## **Appendix A 38262/5501/101 – Bus Access & Circulation**

**STAG BREWERY, MORTLAKE  
POSSIBLE SHEEN LANE AND  
LEVEL CROSSING IMPROVEMENTS**

# Stag Brewery - Chalkers Corner

### Air Quality Monitoring Report

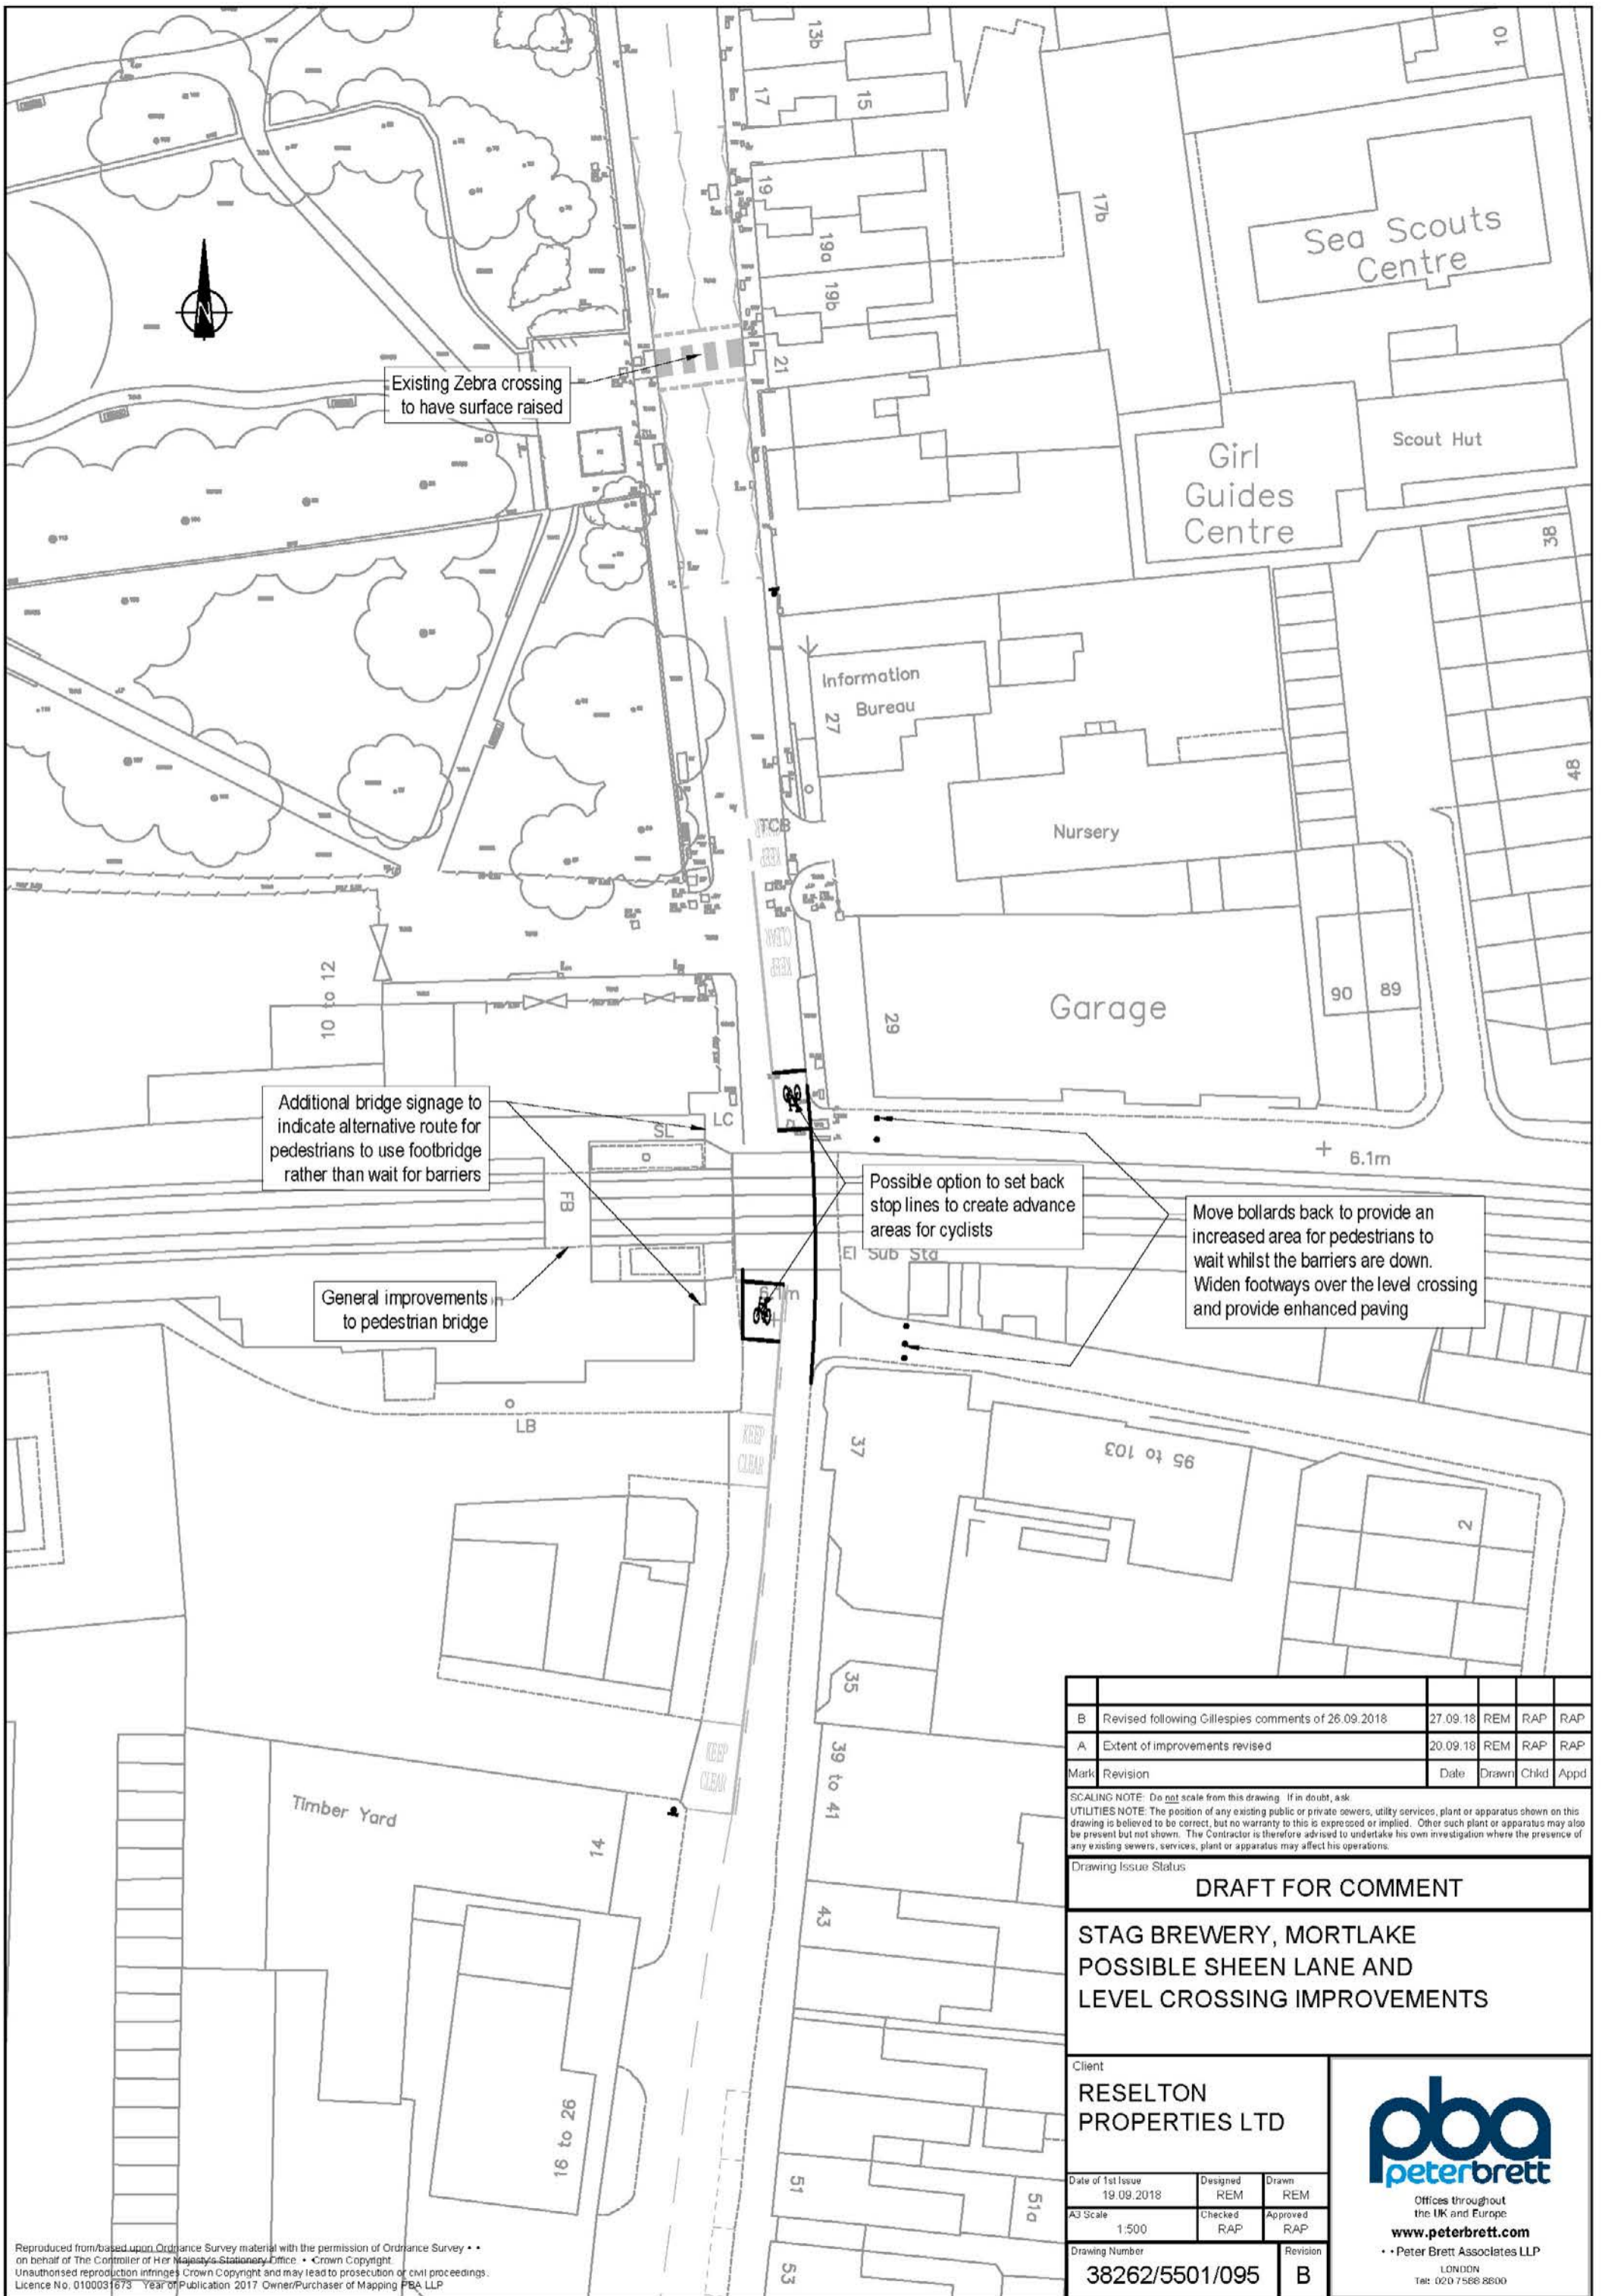
Existing Zebra crossing to have surface raised

Additional bridge signage to indicate alternative route for pedestrians to use footbridge rather than wait for barriers

General improvements to pedestrian bridge

Possible option to set back stop lines to create advance areas for cyclists

Move bollards back to provide an increased area for pedestrians to wait whilst the barriers are down. Widen footways over the level crossing and provide enhanced paving

B	Revised following Gillespies comments of 26.09.2018	27.09.18	REM	RAP	RAP
A	Extent of improvements revised	20.09.18	REM	RAP	RAP
Mark	Revision	Date	Drawn	Chkd	Appd
